HOWARD UNIVERSITY

**SUBJECT: ADDITIONAL INFORMATION REQUESTED FOR AMENDMENT
APPLICATION – MAIL CONTROL NOS. 582468 AND 582469**

Please see the below in response to your request for additional information to support the application to amend NRC licenses 08-00386-19 and 08-03075-07:

1 PARTIAL PLAN - BASEMENT
SCALE: 1/4" = 1'-0"

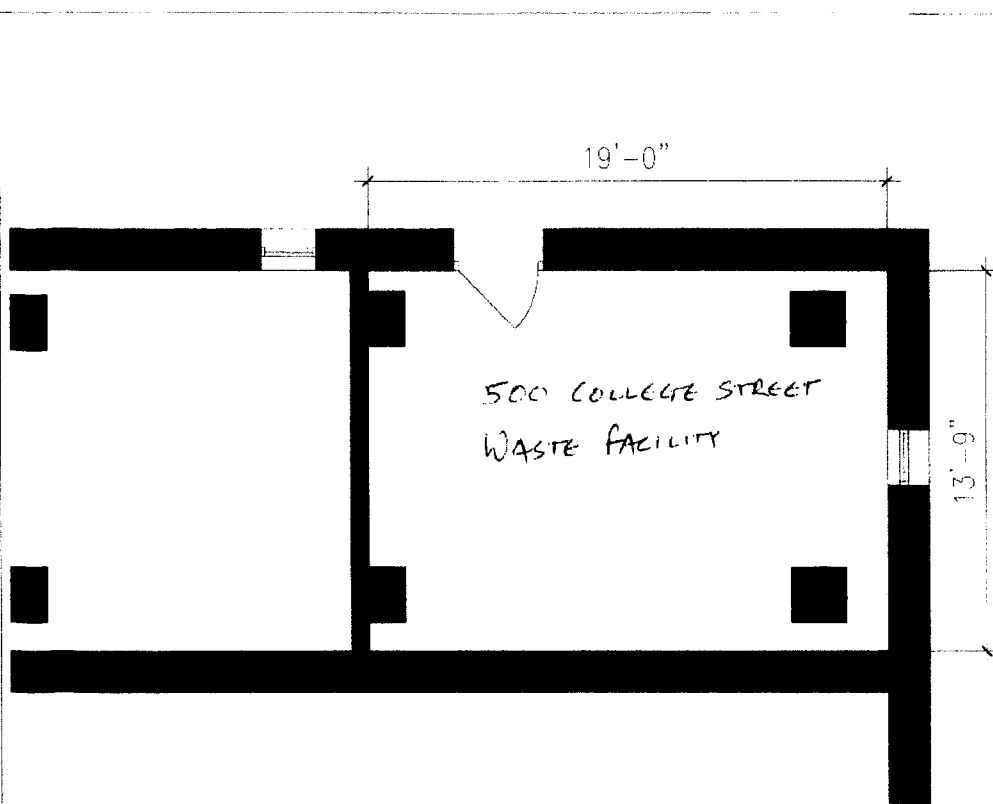
2. **Additionally the Attachment 1 -detailed map of the site seems to be missing for the Annex I waste facility. Is this the same facility indicated as 501 Bryant Street on your 08-03075-07 license, Condition 10? Attachment 1 is also not clear for the 500 College Street facility. Although there is a map included which appears to be the area the room dimensions referenced as 13'9" x 19' are not indicated. Please clarify.**

- a. Detailed map of the sites (Basement of Annex I and 500 College Street buildings) are attached. The waste storage facilities in both of these locations are now indicated on the map. The dimensions of the waste facility in Annex I are 11'6" x 6'6", and those of the waste facility in 500 College Street are 13'9" x 19'.

2 KEY PLAN - ANNEX I - BASEMENT
SCALE: NTS

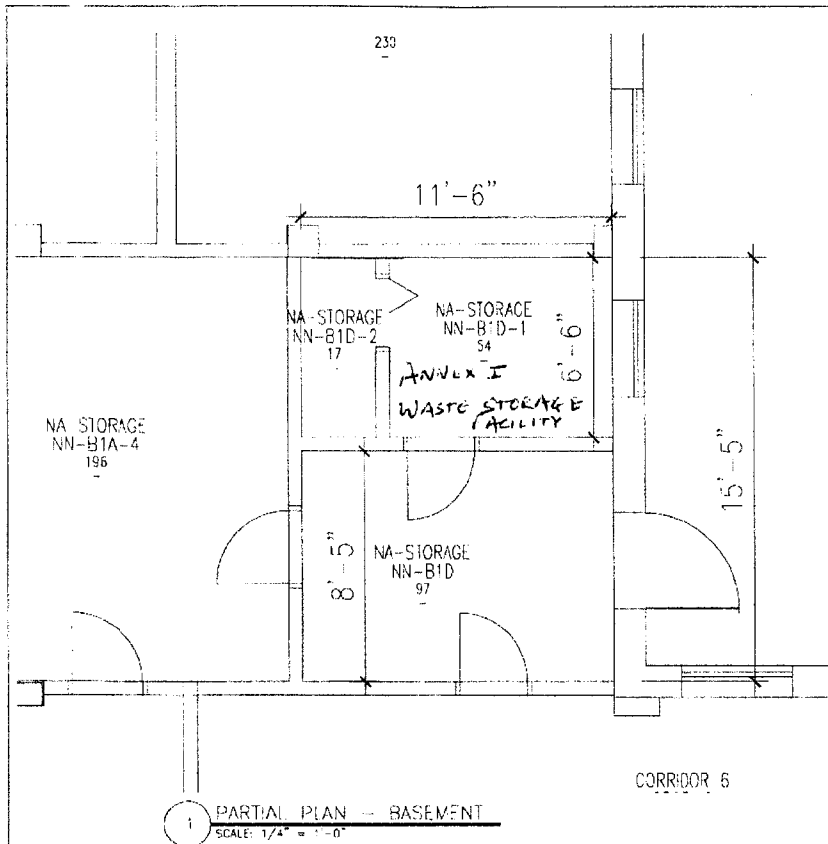
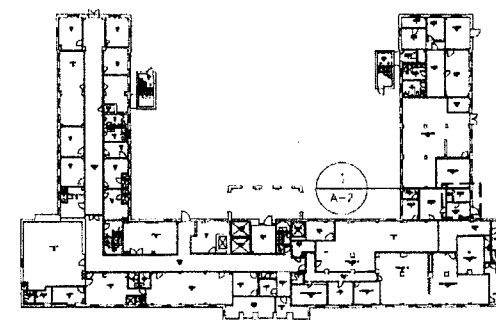
Annex-I waste Storage Facility
is shown on this Diagram
